ADDENDUM NO. 1

DATE OF ISSUANCE: Friday, March 15, 2024

PROJECT: Shirley's Arbor

ARCHITECT'S PROJECT NO.: 23-200.00

ADD-1 Item No. D-1 - Cover Sheet

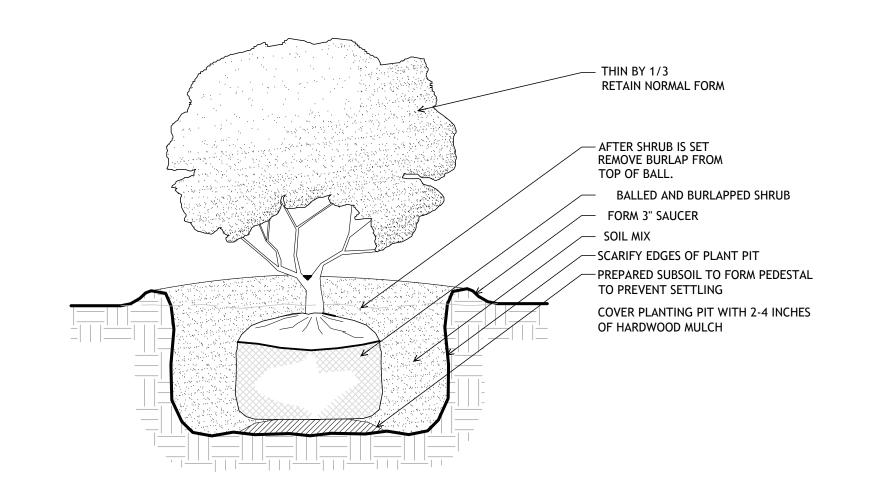
Drawing Index: L101, Site Landscape Plan, is added to the coversheet index.
